STATE OF CONNECTICUT
CONNECTICUT SITING COUNCIL

RE: **SUB-PETITION NO. 1293- MGHACL -02 (Manchester, Glastonbury, Hebron, Andover, Columbia and Lebanon)**– Eversource Energy declaratory ruling that no Certificate of Environmental Compatibility and Public Need is required for all transmission facility asset condition maintenance improvements statewide to comply with the updated National Electrical Safety Code clearance requirements.

Re: Sub-Petition No. 1293-MGHACL-02: 310/368 Line Transmission Line Structure Replacement Project, Amendment to Sub-Petition pursuant to Condition 2 of the Connecticut Siting Council Sub-Petition Approval

310568 Lines - Structure Replacement Project
Hebron, CT
Map Sheet 06 of 17

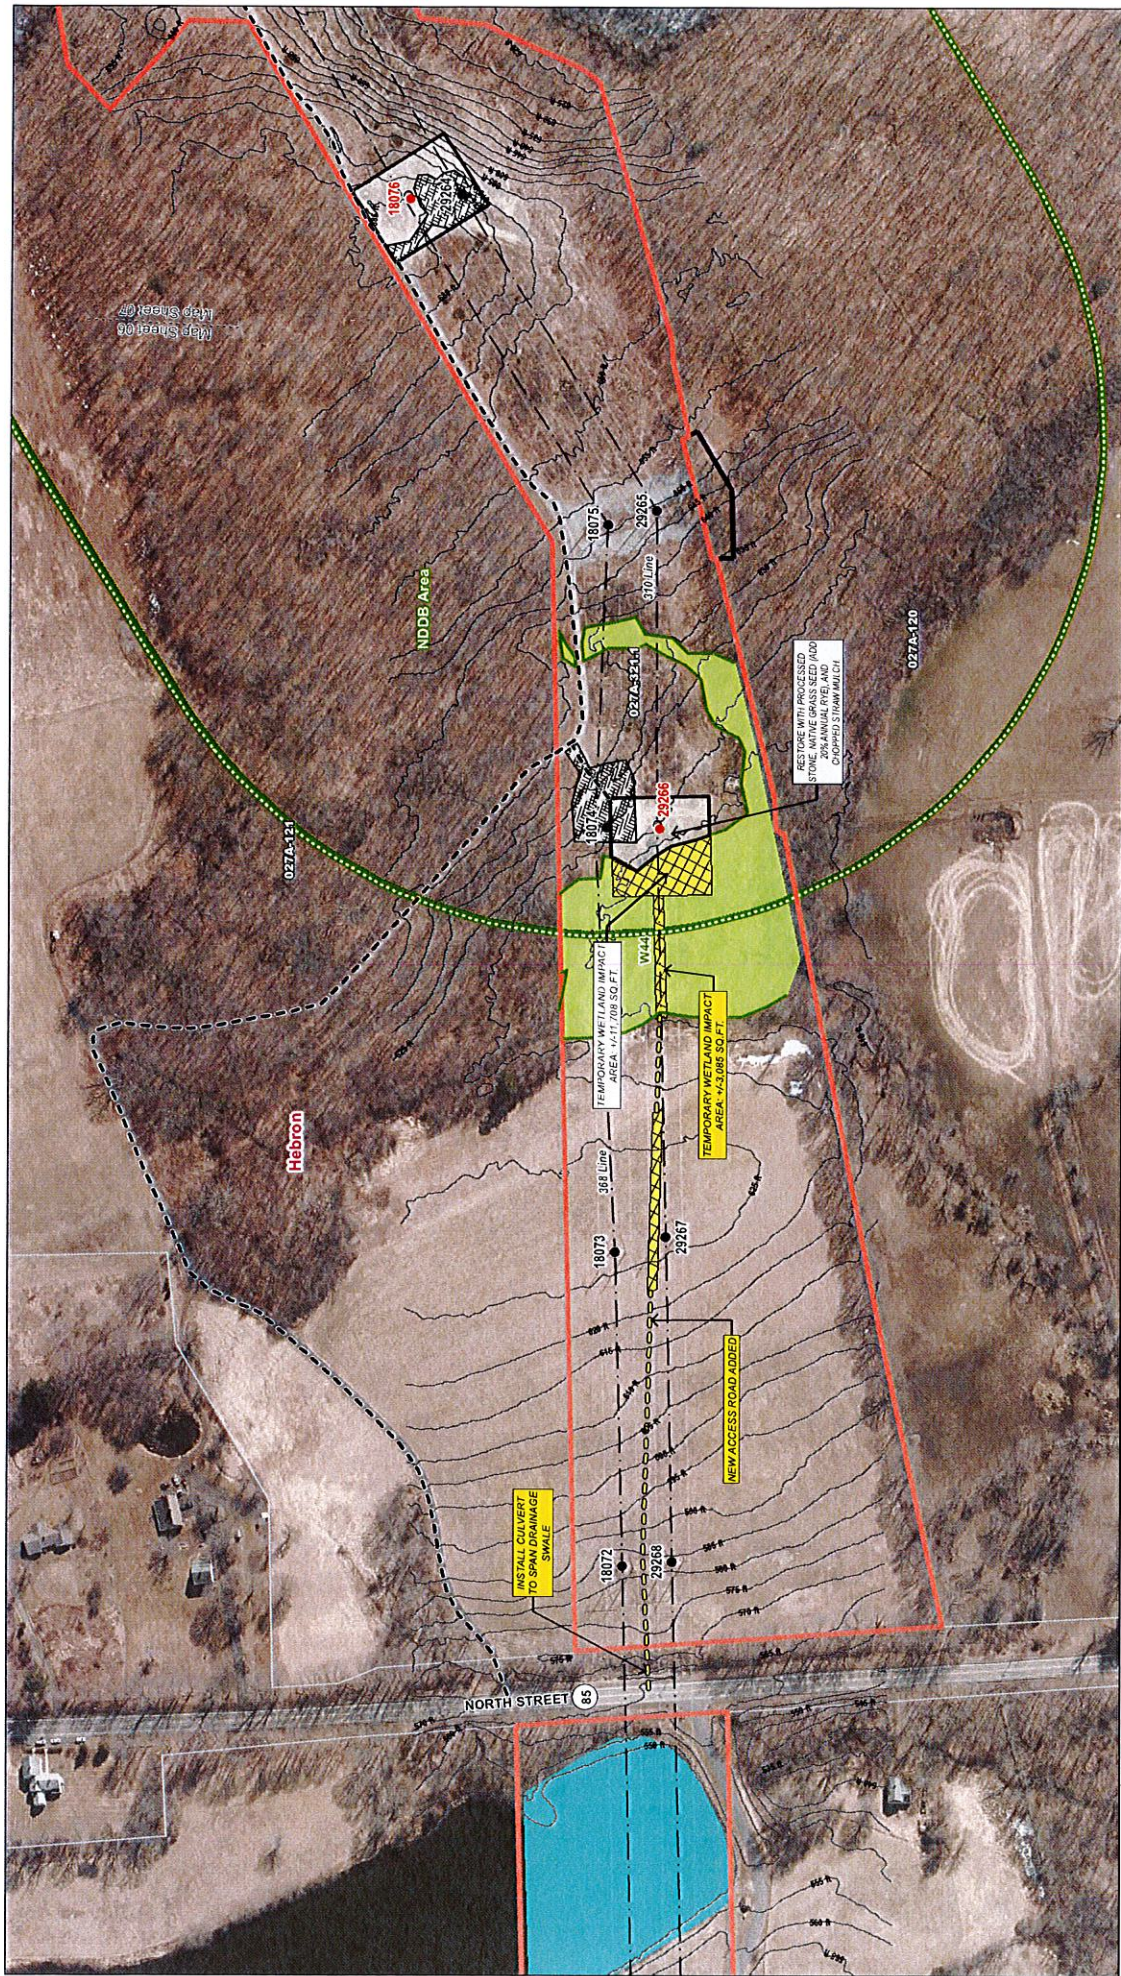
Access to Structure 29266 from North Street (State Route 85), Hebron, CT (Map Sheet 6)

The agreement providing Eversource rights to utilize the off-ROW access to Structure 29266, and other structures within its ROW, has expired and the property owner is not willing to renew the agreement. Therefore, to gain access to its ROW, Eversource is proposing to construct a new in-ROW access road, within its property, extending from North Street (State Route 85) to Structure 29266. The attached map, excerpted from the Sub-Petition filing, has been revised to reflect the location of the in-ROW access road to Structure 29266 (revised Sub-Petition Map Sheet 6).

As detailed on revised Map Sheet 6, temporary construction matting will be used at two locations on the proposed access road. Based on the results of a Phase 1A and Pedestrian Survey conducted by Heritage Consultants, LLC ("Heritage"), a portion of the access will be matted in upland habitat to traverse an archeological sensitive area that is pending a Phase IB Cultural Resource Assessment and Reconnaissance Survey (shovel pit testing). Any additional protective measures recommended by Heritage will be incorporated in the BMPs during construction. This portion of the access road will be made permanent once cultural resource assessments/testing has been completed and Heritage provides assurance that the construction of the road will not impact cultural resources.

Temporary matting will also be used to traverse Wetland 44 ("W44") resulting in approximately 3,085 square feet of additional temporary wetland impacts. Details of the archeological assessment and temporary wetland impacts at W44 are discussed below.

- As detailed on revised Map Sheet 6, the Work Activities associated with the proposed access road to Structure 29266 will result in approximately 3,085 square feet of additional temporary wetland impacts from the use of temporary construction matting at W44. Work would be conducted in accordance with Eversource's *Best Management Practices Manual for Massachusetts and Connecticut (Construction and Maintenance Environmental Requirements)*, September 2016 ("BMPs") to avoid impacts to nearby wetland and watercourse resources.

Added New Access off of Rt. 85
1/19/22
DATE: 1/19/22
NO. 85
FEET NO. 200
SCALE: 1" = 200' HOR.
SCALE: 1" = 100' VERT.

Pursuant to the Council's Petition No. 1293 decision of March 31, 2017 and the July 27, 2021 decision on this sub-petition, your request for the proposed modification is hereby approved. This approval applies only to the project change dated February 3, 2022. Any additional changes to the sub-petition decision require advance notification and approval.
